ADDENDUM NUMBER 2
Prepared by
M. B. Kahn Construction Co., Inc.
Construction Management Division
Columbia, SC
The Boudreaux Group
Columbia, SC
Date of issue: February 8, 2012

ADDENDUM NUMBER TWO

**RCRC Headquarters and Maintenance Building
Project No.: R-715-10**

DATE OF ISSUE: February 8, 2012

F
BIKE RACK
L-2
NOT TO SCALE

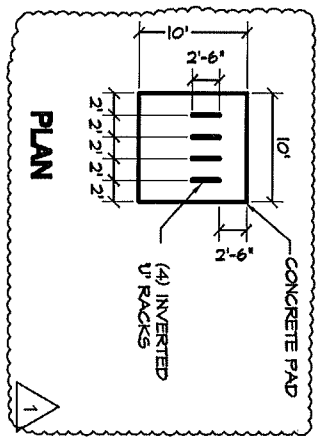
1. Please see attached SK-L-4 clarifying the Bike Rack dimensions indicated on F/L-2 and also provides a plan layout.

INVERTED U' BIKE RACK
 SURFACE MOUNT
 BLACK POWDERCOAT FINISH
 PROVIDE (4) RACKS, MOUNTED 24" O.C. AT 10' WIDE PAD.
 MOUNT 30" FROM END OF PAD.
 MODEL BR-3 BY FAIRWEATHER SITE FURNISHINGS,
 800-925-1785
 OR APPROVED EQUAL
